Q1 Which Elm Street concept do you prefer?

Q2 Do you have comments on the Elm Street Redesign?

Q3 Which option for Front Street do you prefer?

Q4 Do you have comments on the Front Street Redesign?

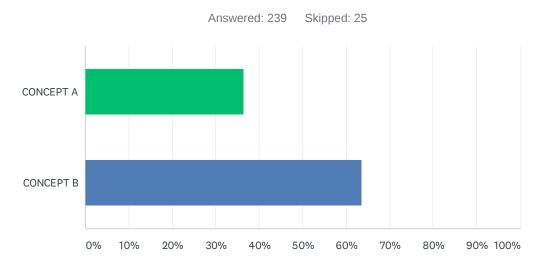
#	RESPONSES	DATE
1	Concept B appeals to me because it is not quite so sharply angled and linear. I think it is important that our streetscape not include just straight lines and sharp corners.	3/5/2020 11:56 AM
2	I have always liked that little spot in town and I like the idea of refurbishing. I like concept A the best.	3/3/2020 7:49 PM
3	I hope you will plant native trees, and more than one type of tree.	3/1/2020 12:15 PM
4	Diagonal parking on north side better than straight in.	2/28/2020 7:34 PM
5	Concept B makes Elm street look more like a parking lot than a thoroughfare, for only three more parking spaces.	2/28/2020 6:03 PM
6	I do not think this project is necessary.	2/28/2020 5:24 PM
7	Traffic needs to be encouraged to drive beyond Elm Street to draw more attention to the North end of Front Street. Perhaps a study needs to be done to see if the traffic pattern on Summer St and Linden St be reversed. this would also draw more attention to Library Park and the Patten free Library.	2/28/2020 8:36 AM

8	I would suggest signage at the end of the street or on the building that lists the stores on the north front street section. Also include that library park and salt pine social are down this way.	2/28/2020 7:09 AM
9	Leave well enough alone	2/27/2020 6:15 PM
10	My thought would be to keep the current design but change the existing perpendicular parking spots to angle parking.	2/26/2020 5:30 PM
11	I like the idea of more parking spaces (and them not being // parking). If the current stores remain at the corner of Front and Elm, they don't have a strong vibe that suggests "come sit here and be social" which is another reason I prefer Concept B over A. It allows for some added social space but won't make it awkward for people "loitering" around businesses that don't cater to social gathering.	2/26/2020 4:46 PM
12	Angled parking makes nose out parking difficult and limits access from one direction	2/25/2020 4:10 PM

13	Great idea	2/25/2020 2:33 PM
14	Angle parking I like, but people will likely try to cross over and park on the opposite side of the street. Nevertheless, I like it better.	2/25/2020 1:24 PM
15	When it comes time to events, there is limited parking along this area. Concept B shows more availability but also a complex situation when there are a lot of people around. I can see this area getting congested easily. Concept A seems a bit more population friendly.	2/25/2020 8:51 AM
16	Wish these had overlays of the existing to clearly understand the changes visually.	2/25/2020 8:47 AM
17	I am a multi-modal transportation planner and was wondering if there was design consideration given to increasing the width of the crosswalks and potentially adding pedestrian activated signals at the crossing. I also did not see any mention of pedestrian scale lighting in the public spaces and was wondering if this is being addressed as well. Thanks and looks like a great project in a much needed area.	2/25/2020 8:46 AM

18	I like both designs but we need more parking so chose B for the added spaces. The mock up for the barrier at Brackets is not a design I would enjoy. I like the concept though. I really feel that more parking needs to open up at City Hall. There are too many reserved spots that are often empty but not available for business at City Hall.	2/25/2020 6:30 AM
19	Protect business owners or tenants signage. Think about adding a shopping / business with area layout to help walkers navigate the area.	2/24/2020 8:23 PM
20	Why? Seems like a waste of money to do street/parking modifications. More visibility aids - banners, etc. are needed to get peds down to the additional merchants. The streets are not the issue.	2/24/2020 7:52 PM
21	This is really exciting. I agree that the shops along this stretch of Front Street are somewhat cut off and these plans seem like they will help improve the pedestrian experience and the visual connection across the intersection.	2/24/2020 7:11 PM

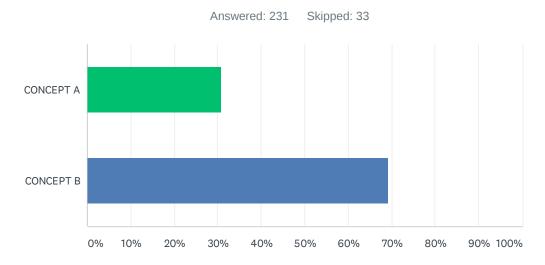
45	Widen and landscape the Front Street sidewalk only and omit the Elm street work.	2/15/2020 7:30 PM
46	Money could be spent in other places like fixing roads that haven't been paved in years!	2/15/2020 11:37 AM
47	I would suggest removing 1 or 2 parking spots on the north side of the streets and install bike racks in the space. I see no accommodations for cyclists navigating the street. Sharrows, bike lanes etc. The angle in parking in concept B is dangerous for cyclists.	2/14/2020 6:36 AM
48	This is a bad idea and not needed. The current area provides for a shaded area -good in summer. You looking to move the public space into the sun. The proposed vegetation will also hinder visibility. There are certainly better places to spend money. Fix the roads, fix the sidewalks, pay for the high school, address the brown tail moth problem, lower our taxes	2/13/2020 4:47 PM
49	It is unclear from the conceptual plans if there are handicap accessible parking areas. This area of downtown currently is less than idea for accessibility so expanding some spaces would be ideal to help those with special needs a safe place to park and access the north side of front street.	2/13/2020 1:20 PM

50	We are working on a project on Elm between the 2 buildings shown and will need a curb-cut in that location, which will delete 3 (?) parking spaces if they are head in, and I think 4 if they are diagonal.	2/13/2020 10:38 AM
51	Make the sign lower so drivers are warned clearly not to drive up Front Street! From our office windows we watch drivers drive up the wrong way all the time.	2/13/2020 6:19 AM
52	eliminate all front street parking/driving and turn it into a pedestrian plaza.	2/12/2020 10:02 PM
53	Make sure Front Street East sidewalk leads into Brackets lot.	2/12/2020 4:53 PM
54	The slanted parking spaces make much better sense when backing out.	2/12/2020 3:29 PM
55	It would be great if any benches that were added did not face the road or the storefronts, but instead up and down the sidewalks, maybe some facing each other, but far enough apart for comfort, a la in on the Free St. side of 2 City Center in Portland. Also, more trees and more grass to limit gray water and to improve air quality.	2/12/2020 1:39 PM

56	Awesome!	2/12/2020 10:34 AM
57	I like the design of B with diagonal parking.	2/12/2020 7:31 AM
58	This is a busy intersection and the road shouldn't be narrowed. Parking will be more difficult and the trees will obstruct visibility. Neither design represents a significant improvement. Save the money and scrap this project. It's a waste.	2/11/2020 10:23 PM
59	all that angled parking on Elm Street, you have to be kidding. It will be a constant traffic jam	2/11/2020 10:19 PM
60	Waste of taxpayer money	2/11/2020 9:38 PM
61	You need better signage to keep people from driving up Front St in the wrong direction. The intersection is too confusing and people are constantly driving up the one way of Front St. It's dangerous!!	2/11/2020 8:26 PM
62	1. No provisions have been made for safe passage by bicycles. Given the complexity of the intersection and the stated goal of improving the space for bicyclists, this is a significant omission. 2. Neither option appears to address improved traffic flow. That may not be possible due to the area configuration, and it would have been interesting to know what was considered (one way traffic on Elm Street, for example). 3. Were there other ideas proposed for improving the sense of continuity moving from the south to north end of Front Street? 4. Reconfiguration of the Elm Street parking spots is an opportunity to consider paid parking in this vicinity. 5. Possibly a bus / trolley stop could be allocated in the design of either Elm or Front Street.	2/11/2020 8:24 PM

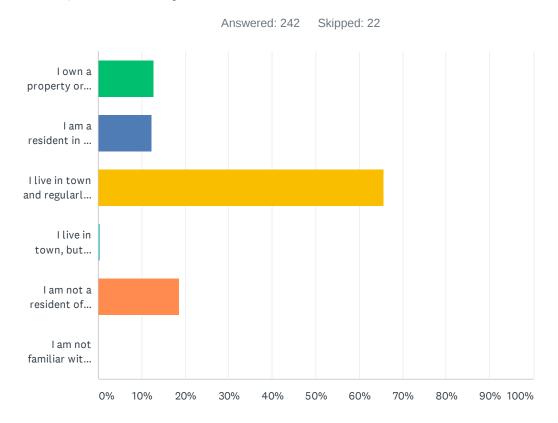
stated project goals. 2. Concept B provides no obvious pedestrian access to the entrance to Bracketts Market or another future store in the same location. This seems a particularly poor

over it. Also, brick sidewalks are pretty but dangerous -- bricks heave out, become loose, hold moisture and easily glaze over with ice. How about some kind of permeable asphalt instead on both Front and Elm?
